Site Plan Review
Permit #: RPPL2016000998
Project #: —
This plan is APPROVED in compliance with the Los Angeles County Zoning Code and subject to the requirements noted herein. This approval shall expire if it is not used within two years of the approval date and prior to any change in ordinance requirements. This approval shall not be construed to permit the violation of any provision of the Los Angeles County Code or State or Federal Law.
Signature: [signature]
Print: RAMON CORDOVA
Date: 08/01/16
Expiration Date: 08/01/18

New Residential Project For:
Miyuki Yokoyama & Paul Nghiem

YOKOYAMA
NGHIEM
RESIDENCE
1555 Delta Ave.,
Rusamead, CA 91770

SITE PLAN 1
SCALE: 1/8" = 1'-0" A101

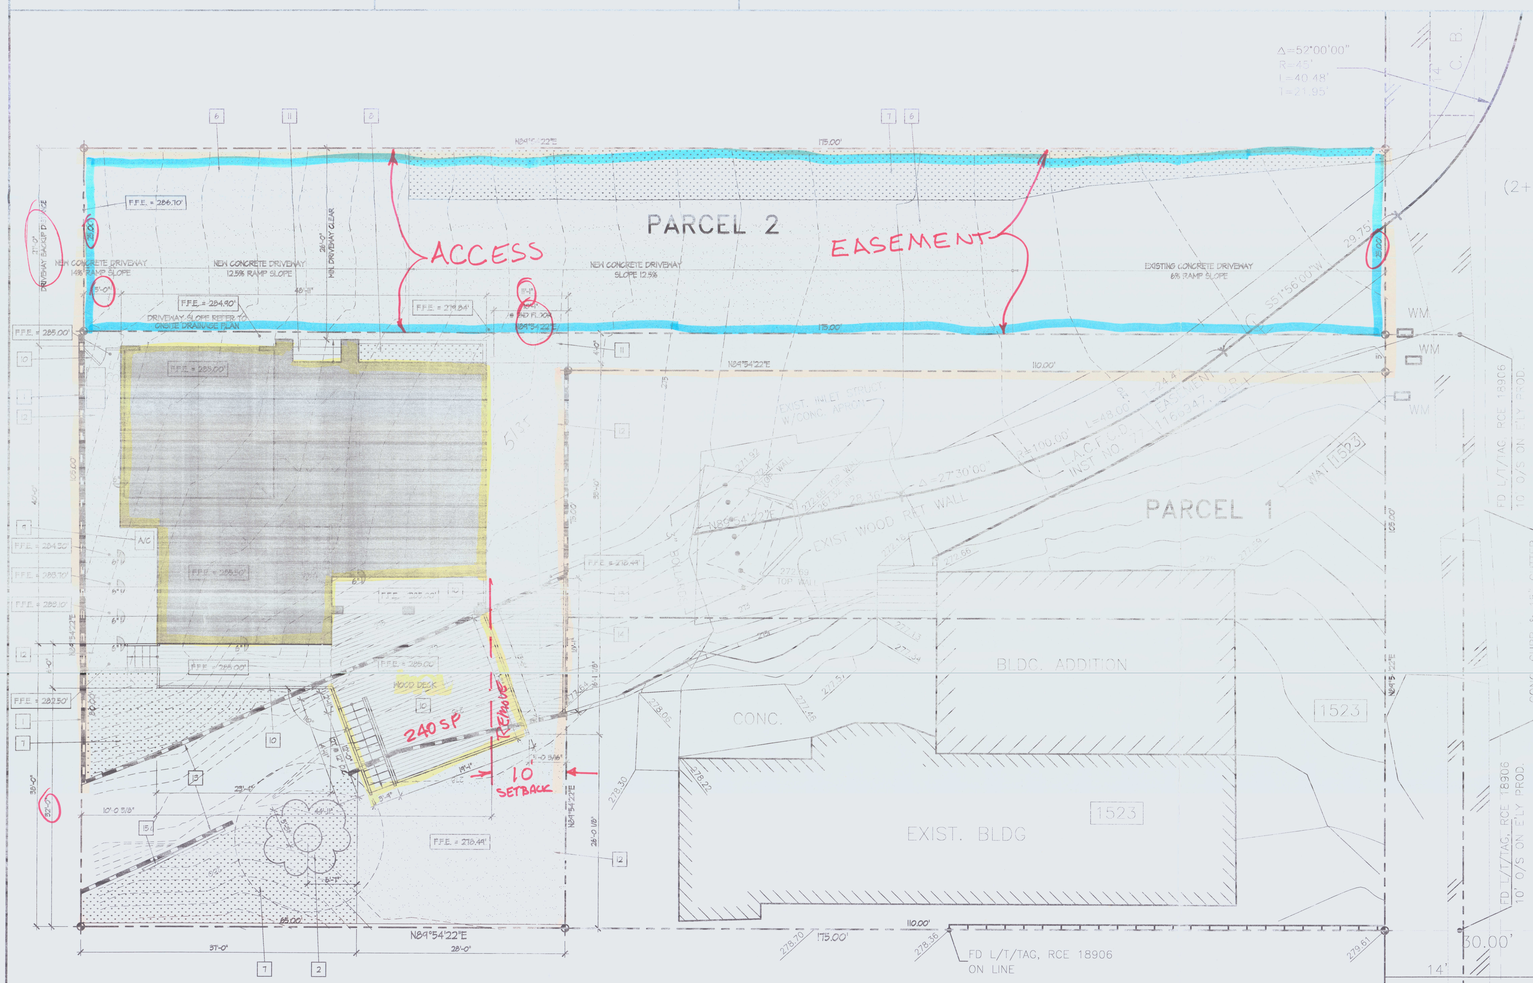
Okay
5,750 SF x .25 = 1437.5 SF
1437.5 SF + 1,000 SF = 2,437.5 SF (MAX)

G.S.A
1,125 SF + 1,310 SF = 2435 SF
2,435 SF < 2,437.5 SF
Okay

LOT COVERAGE
1,125 SF + 454 SF + 69 SF + 103 SF + 240 SF (WOOD DECK) =
1,991 SF < 2,437.5 SF
Okay
